Year 3 Monitoring Report

LITTLE SEBASTIAN SITE

NCDMS Project # 100027 (Contract # 7187) | RFP 16-006993 (Issued 9/16/2016)
USACE Action ID: SAW-2017-01507 | DWR Project # 2017-1041

RE: Little Sebastian, Project ID #100027, DMS Contract #7187

Figure 2
Current Conditions Plan View

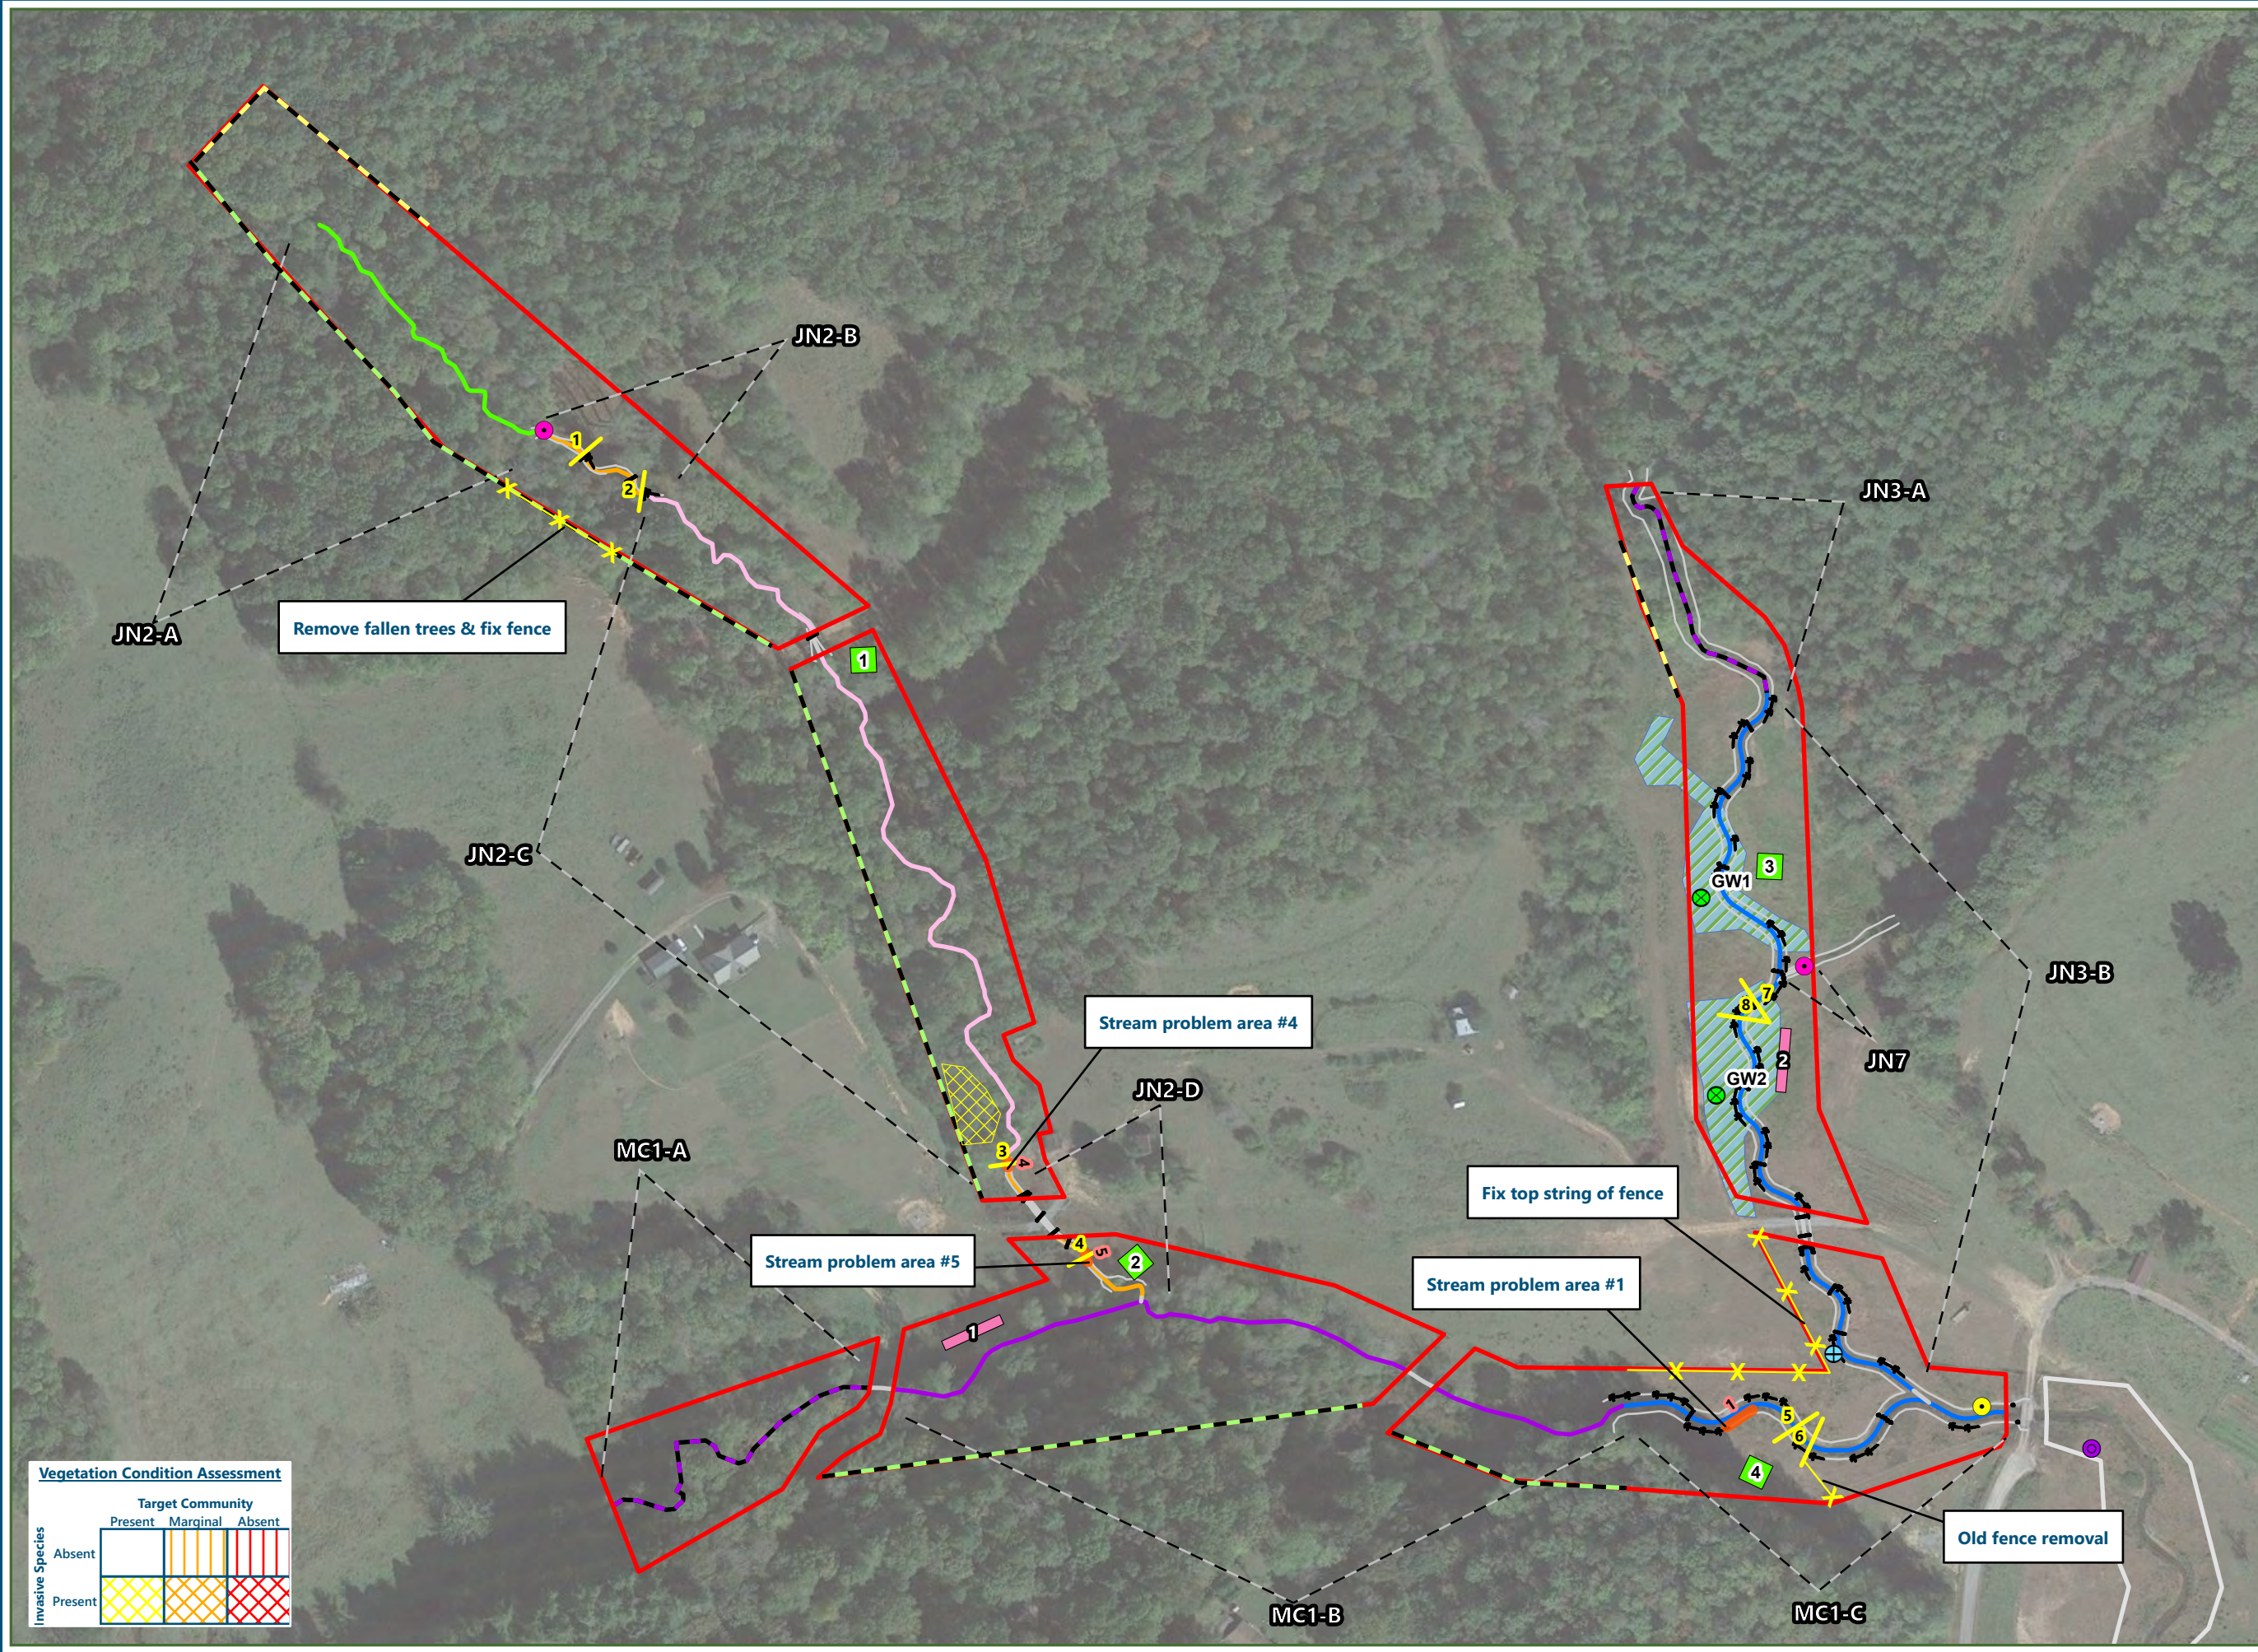
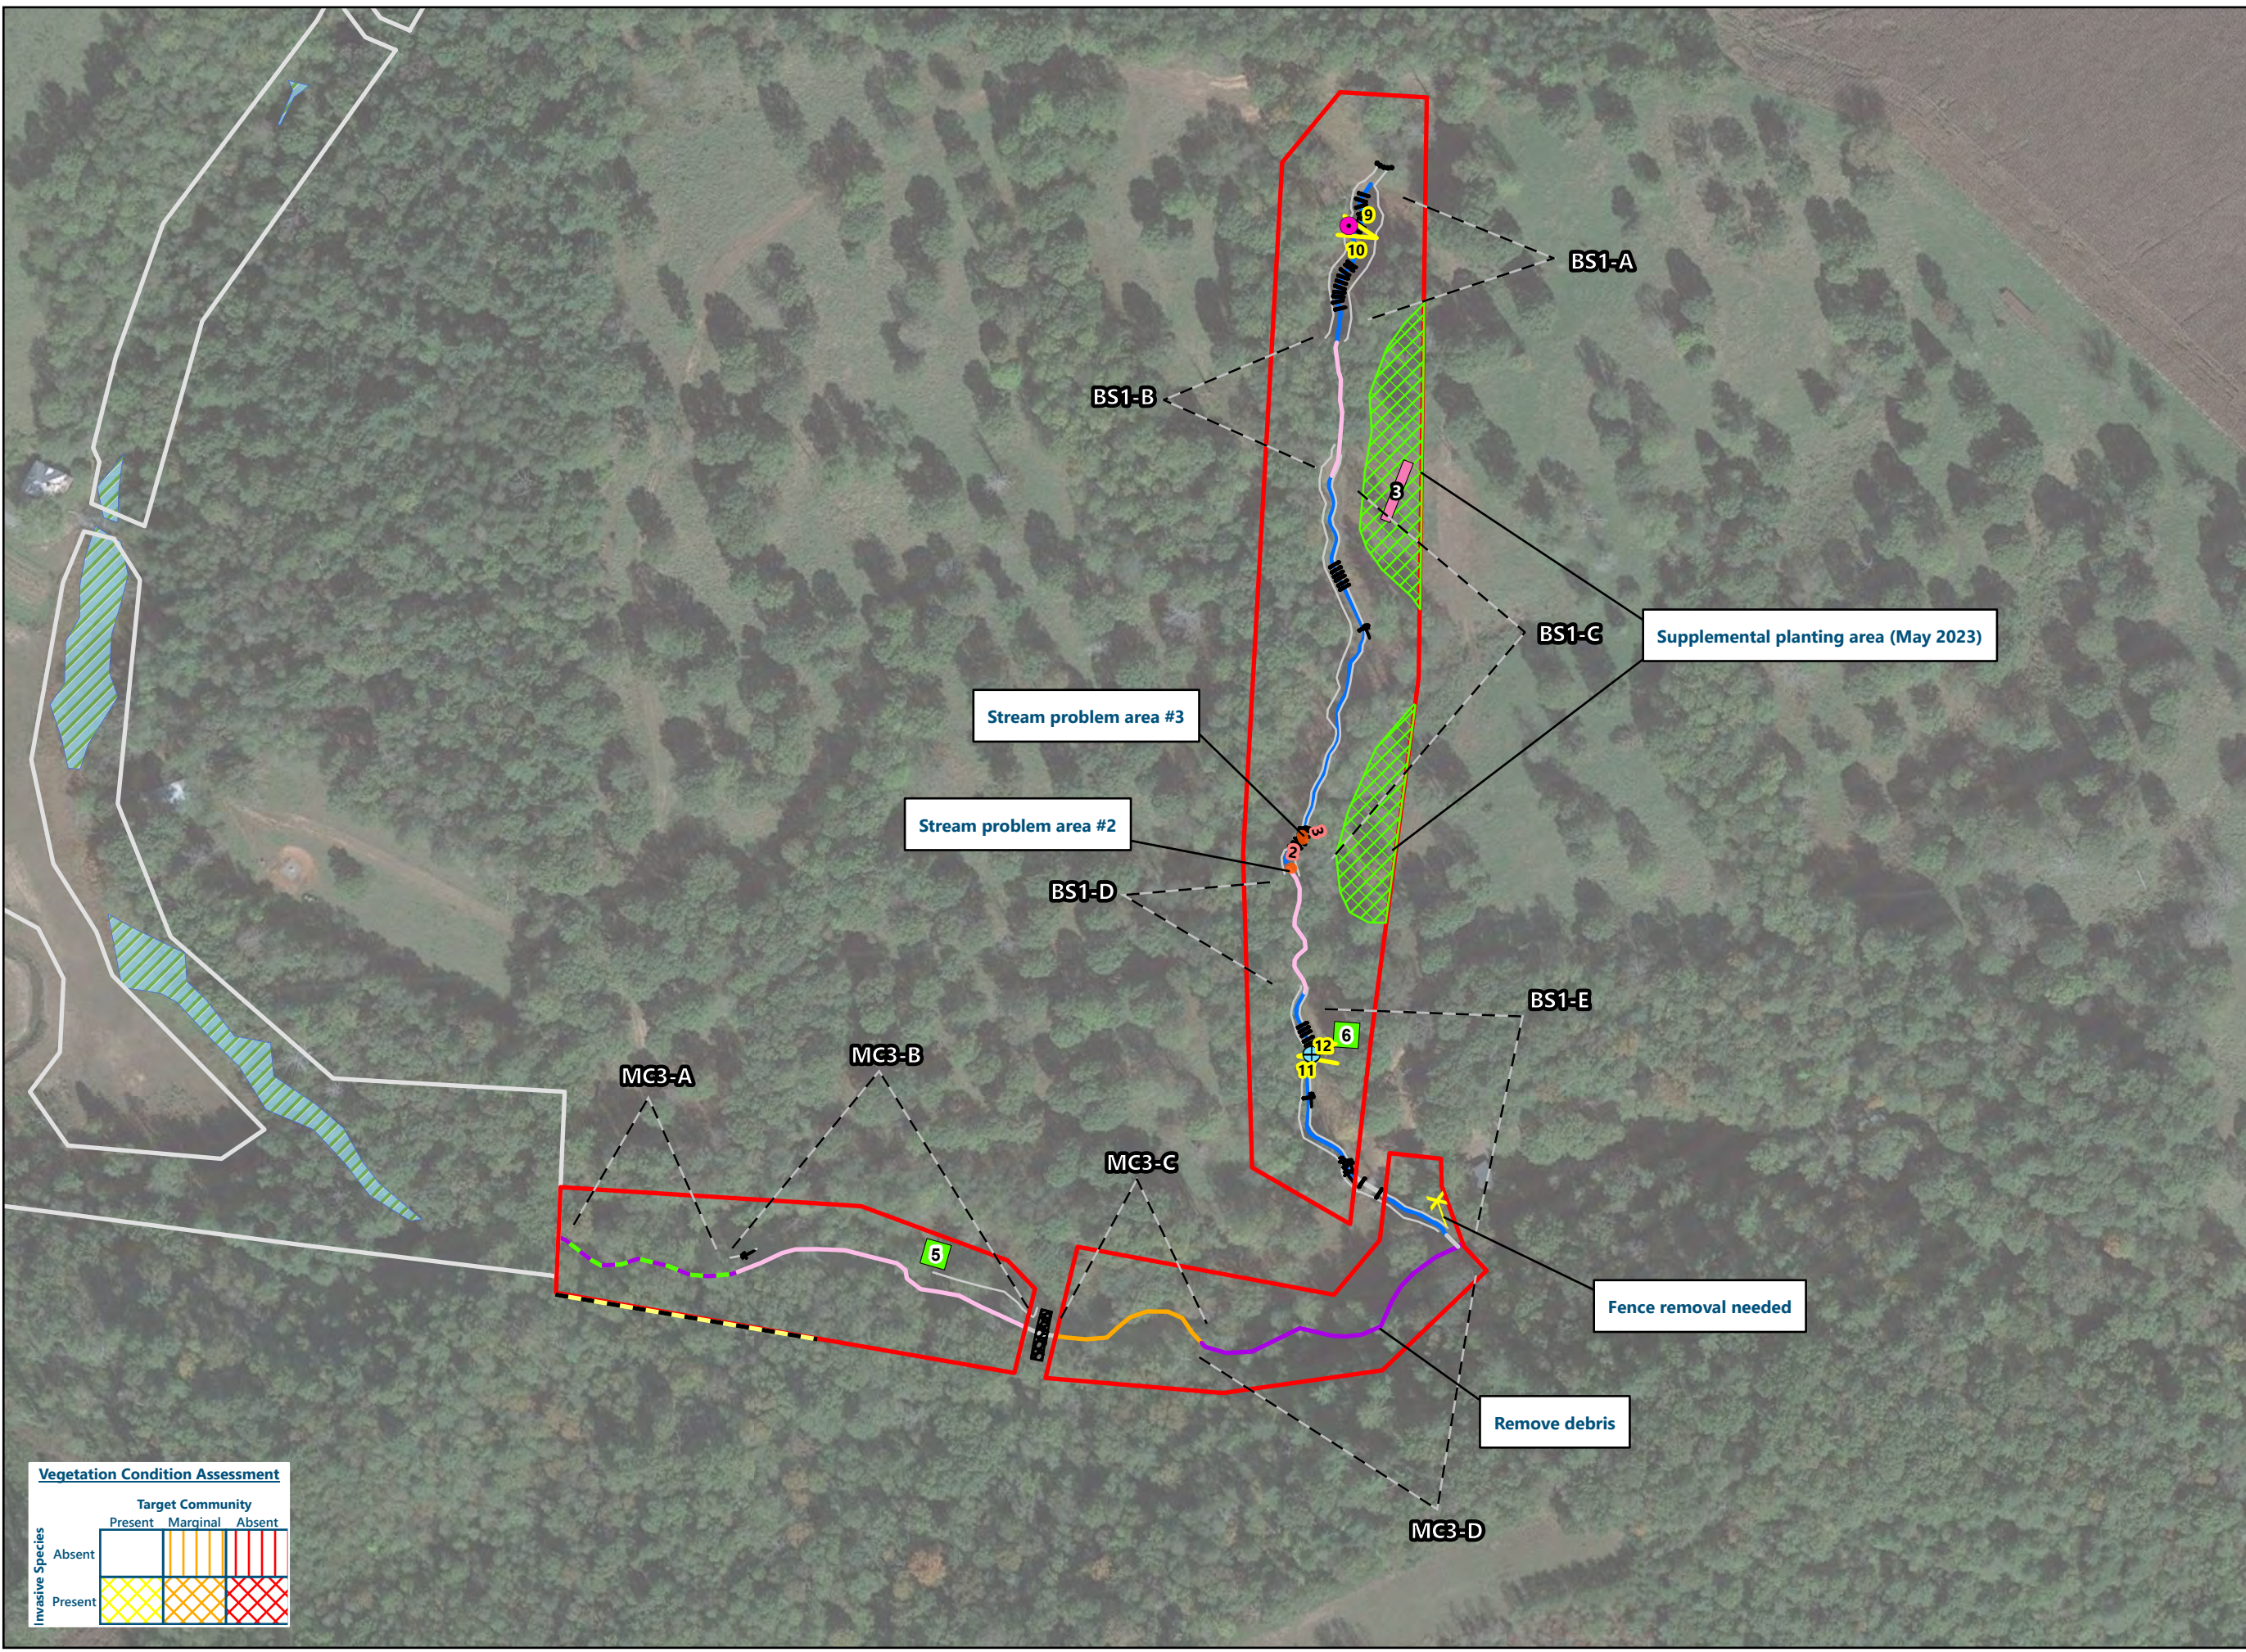
9. Section 1.7 Monitoring Performance (MY3) _Stream Geomorphology: An area of erosion is noted at Right Bank Erosion BS1-C and mapped on the CCPV, and “caused by a failed log sill causing the stream flow to erode away at the right bank”. It is noted that matting and live staking will be completed to stabilize this area in early 2024; however, the photo shows a vertical, eroding bank. Is RES confident that matting and staking can rectify and stabilize the apparently actively eroding bank? Please review and discuss in the report text.

10. Section 1.7 Monitoring Performance (MY3) _Stream Geomorphology: An area of erosion is noted at Right Bank Erosion MC1-C and mapped on the CCPV, and “caused by a brush toe failing during a major storm event”; however, a photo of this area was not included. Is this an area RES also intends to address with matting and live staking, and is RES confident that this approach will stabilize the area? Does RES have an idea which storm event caused this? Please add additional information in the report text to detail the project issue and proposed resolution. The photo of the brush toe failure was previously mislabeled with the wrong reach and has been updated. The CCPV and report now also refer to the stream problem areas by station numbers. RES can not confirm what storm event caused the brush tow to fail but feels confident that the matting, packing with coir logs, and live staking will stabilize the area.

12. General/ Problem Area Photos/ CCPV Maps/ Visual Stream Stability Assessment Tables: It would be helpful if RES could add station numbers to the stream problem area photos and discuss in the report text accordingly by station numbering. Ideally, the CCPVs should show station numbers for reference. If there are multiple areas along the same reach or if these areas are discussed in the future, this helps guide the discussion on their exact locations. Any structure issues reported in the Visual Stream Stability Assessment Tables, or the project photos should be documented on the CCPV Maps. Please review and update the report and maps accordingly.

13. Table 6. Vegetation Condition Assessment Table & CCPV: DMS observed multiple areas of invasives during a November 11, 2023, site visit. Chinese Privet was the prevalent invasive species observed. Please review and confirm that the invasive areas observed on the site are below the mapping threshold (1,000 sq. ft.). Please continue to actively treat invasives on the project site through the monitoring term and report treatments in Table 2. Project Activity and Reporting History.

After RES investigated BS1-C on February 22nd, 2024, the plan for stream problem area #2 and #3 is to rebuild the piping log sill and add riffle material upstream of that log sill to convert the step-pool feature into more of a cascade feature and rebuild the left bank above that sill with a soil lift. Also, to notch the log sill above the piping log sill to give the low flow a preferential path that isn’t under the left bank. Furthermore, RES will rebuild the right bank below the last log sill with a stone toe.

The photos, CCPV, visual stream stability assessment, and monitoring report have all been updated based on the comments through out this report. The stream problem areas have also been given station numbers which can be seen in the photo log, CCPV, and the monitoring report.

One area that is approximately 4,500 square feet has been added. The RES maintenance team will treat this area and spot check the whole site during MY4 (2024). Areas that have been treated will be included in the MY4 report.

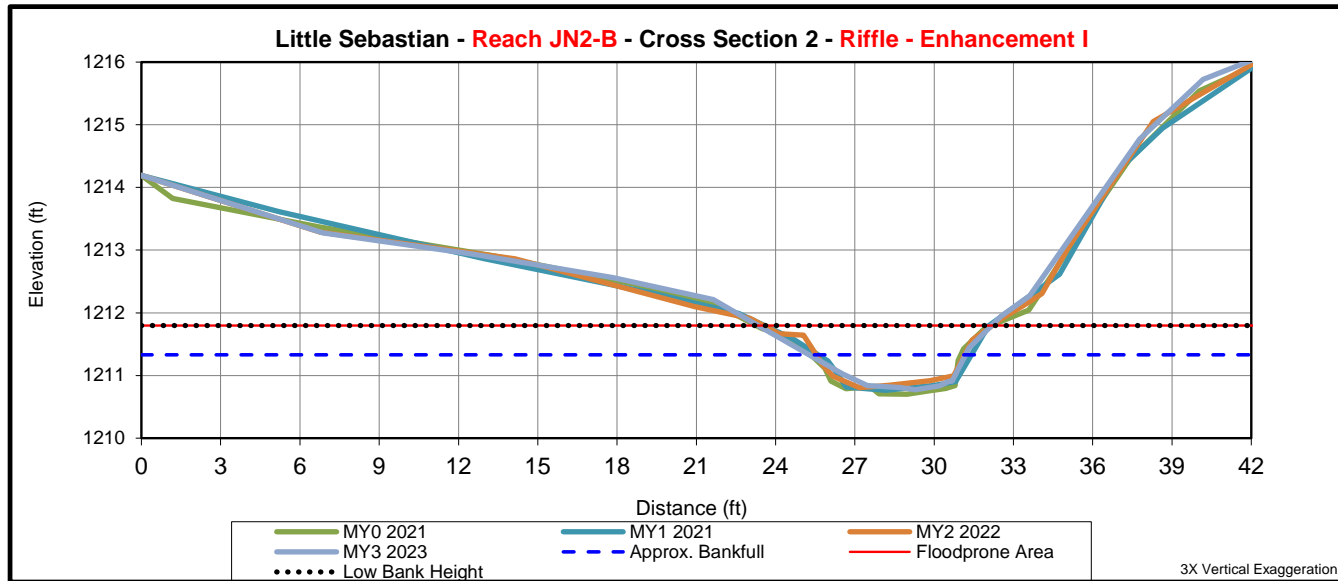
8. Section 1.7 Monitoring Performance (MY3) _Stream Geomorphology: The text reports that "Overall the MY3 cross sections and profile relatively match the proposed design.". Cross Section 2 is briefly discussed. In addition, two riffle cross sections (Reach JN2-C - Cross Section 3 and Reach JN2-D - Cross Section 4) show significant downcutting. RES indicates that they will investigate potential causes of this issue in early 2024 and will report findings in the future. Please discuss/assess this area in the current report, as it occurred in MY3 (2023). If RES feels the profile matches the design, please discuss how the profile was assessed? Visually?

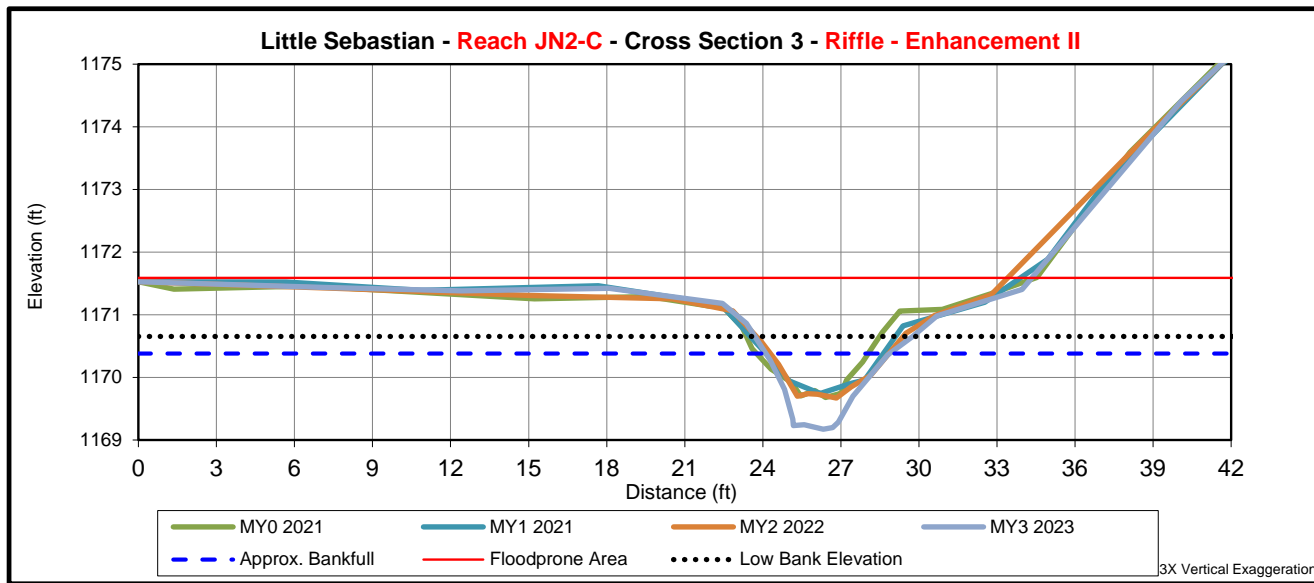
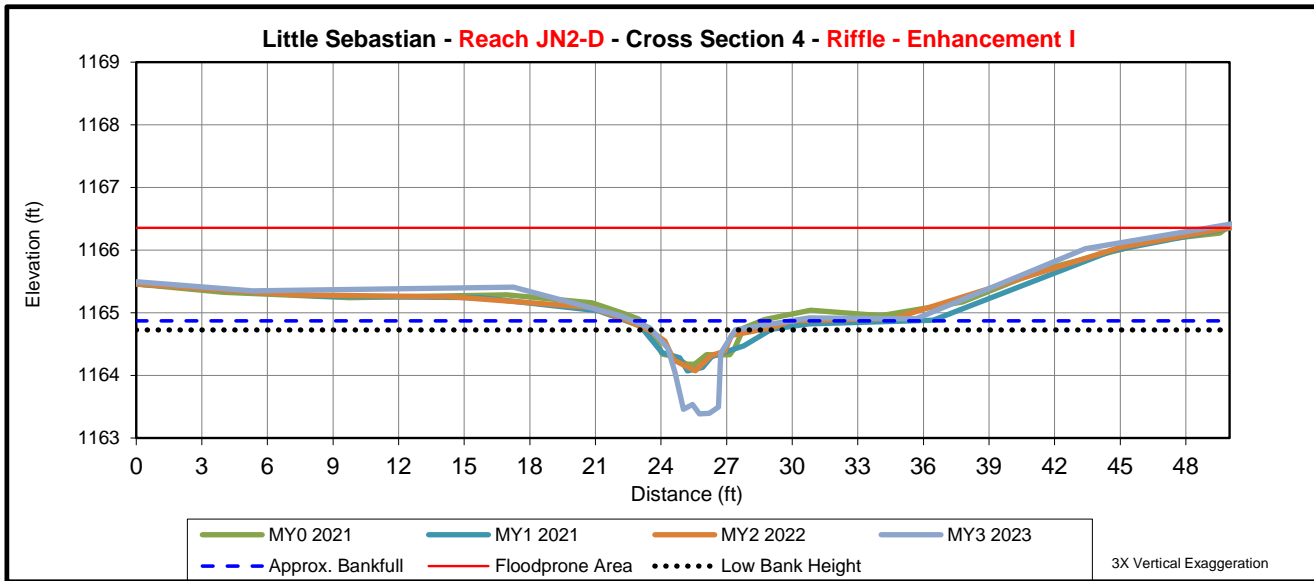
19. General: While cross sections are not typically required during MY4(2024), please consider providing cross sections for Reach JN2-C - Cross Section 3 and Reach JN2-D - Cross Section 4 in MY4(2024), in an effort to keep tracking their trend due to the sudden changes reported in MY3(2023).

The text in Section 1.7 has been changed to state that "Overall the MY3 cross sections relatively match the as-built conditions". RES investigated cross section 3 and 4 (stream problem area #4

and #5) on February 22nd, 2024, and it appears that the downcutting seen is the riffle material moving downstream. RES will add material to lift the channel bed back to the proposed depth, the new material will be sized to be less mobile. This maintenance work will be scheduled to happen in 2024. The cross sections were accessed visually in the field and also using past monitoring data.

RES will provide cross section data for XS 3 and 4 for MY4 (2024).
